UNITED STATES OF AMERICA  
BEFORE THE  
FEDERAL ENERGY REGULATORY COMMISSION

Docket No. RD14-2-000

**MOTION TO INTERVENE, PROTEST AND INITIAL COMMENTS OF THE  
ELECTRICITY CONSUMERS RESOURCE COUNCIL (ELCON),  
AMERICAN FOREST & PAPER ASSOCIATION (AF&PA),  
COUNCIL OF INDUSTRIAL BOILER OWNERS (CIBO), AND  
AMERICAN FUEL & PETROCHEMICAL MANUFACTURERS (AFPM)**

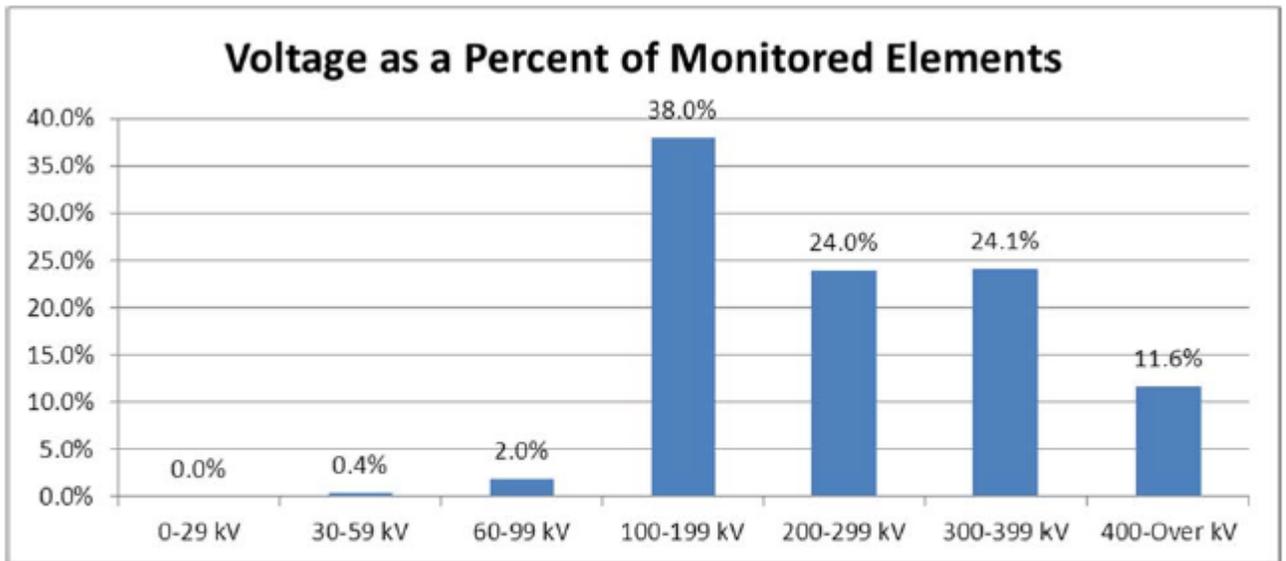
The results are stark: “the number of below 100 kV transmission line elements comprised less than 2.5% of the total monitored key element groupings.”<sup>16</sup> The following Figure 1 from the NERC White Paper summarizes the results:

These data present strong support for a 70kV threshold, as only a very small percentage of elements at voltages below that level have been deemed to raise a potential reliability issue that warrants monitoring. As noted above, it would be far more efficient to establish a 70 kV threshold and apply the Exception Process to those few outlier elements if and as necessary.<sup>17</sup> Instead, by inappropriately adopting an unduly conservative, “zero tolerance” approach, NERC’s takeaway from this step of its assessment was a threshold of 30 kV.<sup>18</sup>
